**OVP HEALTH CARE, INC.
LAWRENCE COUNTY, OHIO
FAIRLAND HIGH SCHOOL CLINIC
ADDENDUM #2
AUGUST 19, 2026
THRASHER PROJECT #T60-11686**

A MANDATORY Pre-Bid Conference was held on Thursday, August 13, 2026, on the above-referenced project. A copy of the sign in sheet is attached in this addendum. The following are clarifications and responses to questions posed by contractors for the above-referenced project.

The following drawings have been revised in this addendum:
A1.01, A4.01, A5.01, E1.01 and E2.01.

E2.01

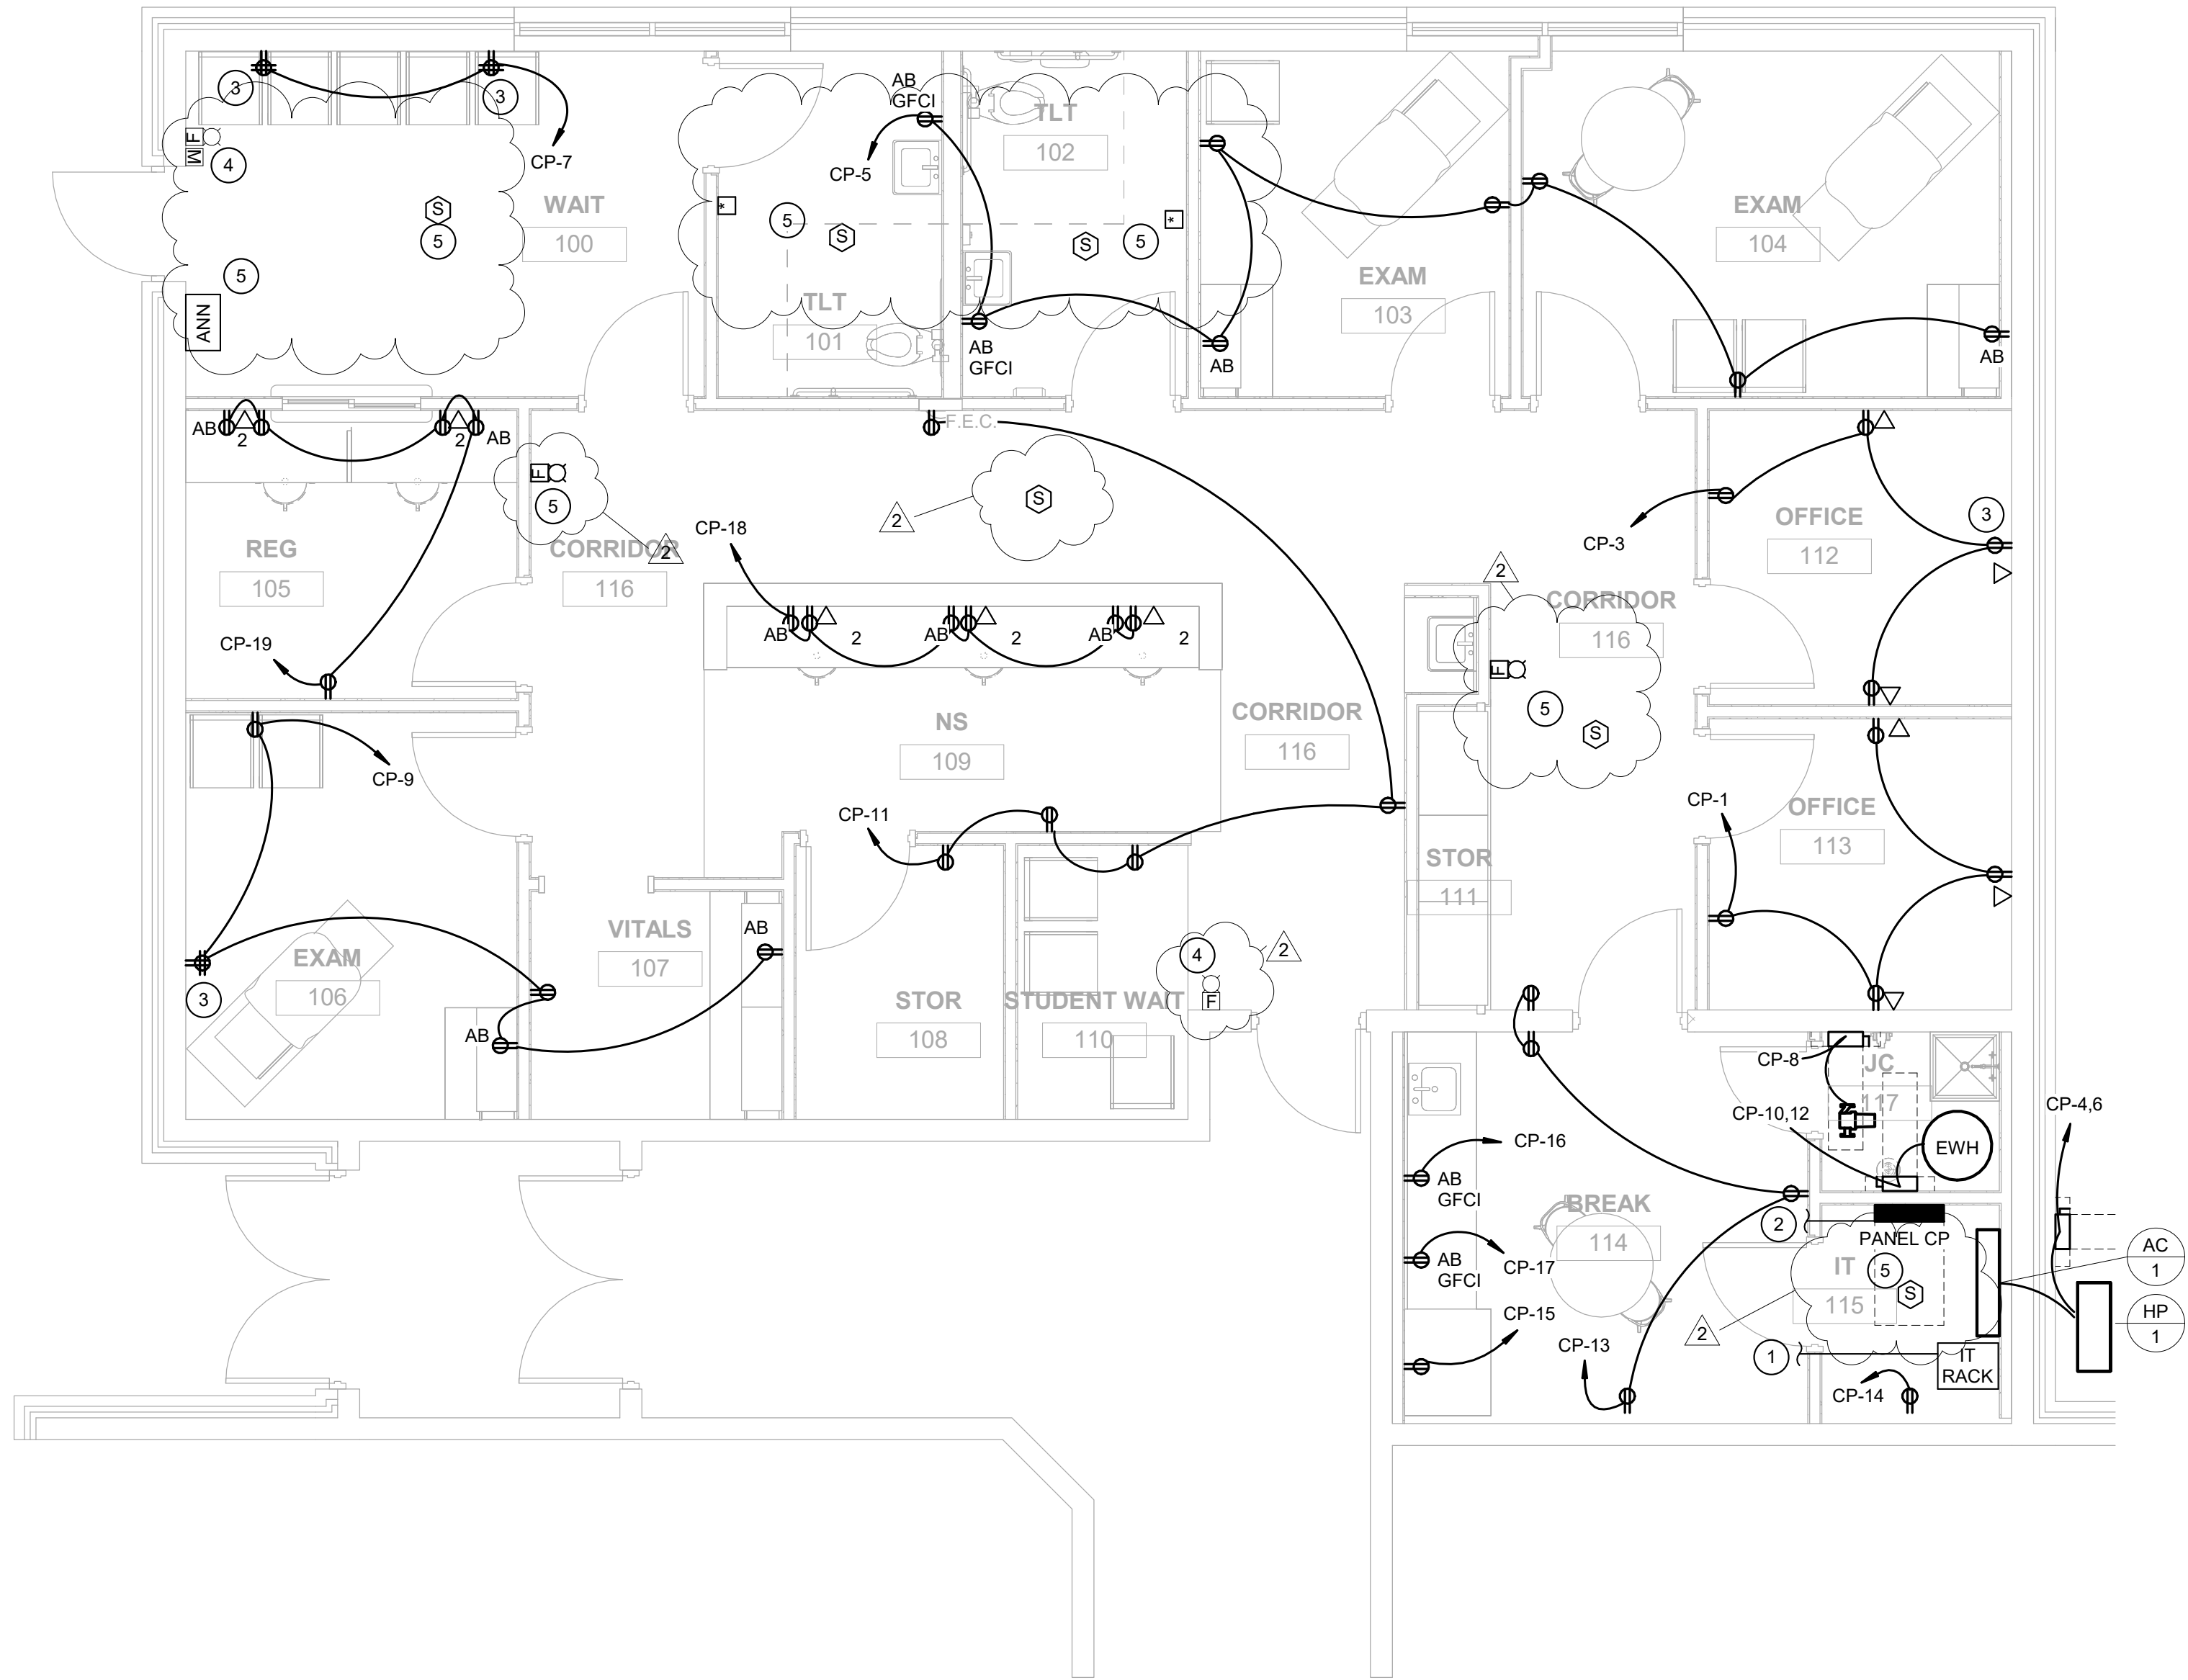
Panel CP schedule on sheet E6.01 calls for a 120/208V 3PH 4W panel however the feeder listed on sheet E2.01, key note #2 is only good for a single phase 120/240V panel. Please clarify.

Will this project require Fire Alarm? Nothing is shown on the electrical drawings provided. There are FA System notes and FA general notes but no equipment or devices shown on electrical drawings.

Note 2 on E2.01 updated to show 4 – 4/0awg, 1 - #4GND in 2 1/2" conduit.

Yes, Addendum #2 will show existing and new fire alarm devices on drawing E2.01. Connect devices to existing fire alarm control panel. Coordinate with owner for exact location of fire alarm control panel.

NEW WORK FLOOR PLAN - POWER KEYNOTES	
NUMBER	DESCRIPTION
1	CONNECT TO EXISTING DATA RACK WITH A 2" CONDUIT FOR CONNECTION TO EXISTING COMMUNICATIONS. COORDINATE WITH IT PERSONNEL AND OWNER FOR DETAILS ON CONNECTING THE NEW IT RACK TO EXISTING COMMUNICATIONS. ELECTRICAL CONTRACTOR SHALL PROVIDE AND INSTALL CONDUIT FOR IT RACK. DATA CONTRACTOR SHALL PROVIDE AND INSTALL CABLING, EQUIPMENT, RACKS, ETC.
2	CONNECT NEW PANEL "CP" TO EXISTING MDP. COORDINATE WITH OWNER FOR MDP LOCATION. PANEL "CP" SHALL BE FED FROM EXISTING MDP WITH 4 - 4/0AWG, 1 - #4GND IN 2 1/2" CONDUIT.
3	REUSE EXISTING RECEPTACLE FOR INSTALLATION OF NEW CIRCUIT. EXISTING WIRES AND CONDUIT MAY BE REUSED FOR NEW INSTALLATION.
4	EXISTING FIRE ALARM DEVICE.
5	CONNECT NEW FIRE ALARM DEVICES TO EXISTING FIRE ALARM CONTROL PANEL. COORDINATE WITH OWNER FOR LOCATION OF FIRE ALARM CONTROL PANEL.
